# Access Compliance Report

## Public Rights-of-Way

Intersection ID: 15287	Main Street: ALBEMARLE_RD	Cross Street: N_SHARON_AMITY_RD	Location: NE
ADA ID: E227B227B5C3	Ramp Type: Perp	Initial Pass/Fail: Fail	Overall Compliance: No
Severity Score: 25			
Codes/Mitigation Info/Possible Solution		Field Measurements/Component Compliance

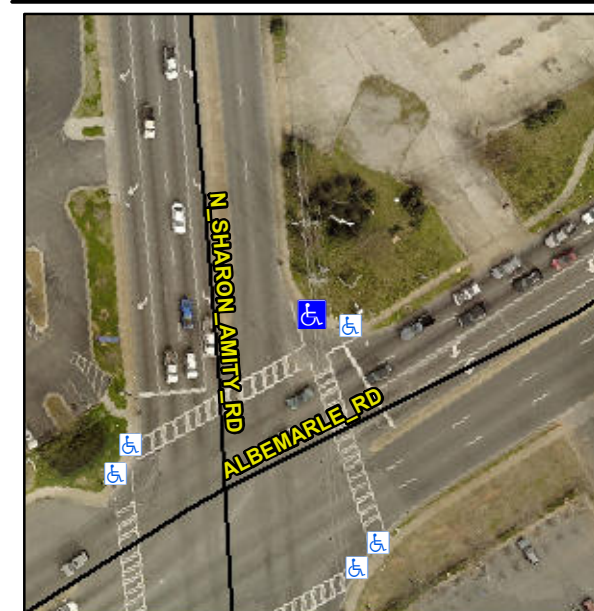
**Not Found, R304.2.2, R304.5.3**

Compliance	Description	Data	Compliance	Description	Data
N/A	Ramp Length (in)	58.0	No	Ramp Slope (%)	10.2
Yes	Ramp Width (in)	48.0	No	Ramp XSlope (%)	6.5
N/A	Flare Type LT	N/A	N/A	Flare Type RT	N/A
N/A	Flare Slope LT (%)	N/A	N/A	Flare Slope RT (%)	N/A
N/A	Flare Traversable LT?	N/A	N/A	Flare Traversable RT?	N/A
N/A	Landing Length (in)	N/A	N/A	DWS Provided?	N/A
N/A	Landing Width (in)	N/A	N/A	DWS Contrast?	N/A
N/A	Landing Slope (%)	N/A	N/A	DWS Length (in)	N/A
N/A	Landing X Slope (%)	N/A	N/A	DWS Full Width?	N/A
N/A	Landing Curb? (Y/N)	N/A	N/A	DWS Offset (in)	N/A
N/A	Shared Landing?	N/A			
N/A	Gutter Ponding?	N/A	N/A	Gutter Slope (%)	N/A
N/A	Gutter Lip Ht (in)	N/A	N/A	Gutter X Slope (%)	N/A
N/A	Painted X Walk1?	Yes	N/A	Painted X Walk2?	N/A
	X Walk 1 Direction	To W		X Walk 2 Direction	N/A
N/A	X Walk 1 Width (in)	106.0	N/A	X Walk 2 Width (in)	N/A
	X Walk 1 Slope (%)	3.8		X Walk 2 Slope (%)	N/A
	X Walk 1 X Slope (%)	4.3		X Walk 2 X Slope (%)	N/A

**Remove & Replace Entire Ramp.  
Restripe Crosswalk.**
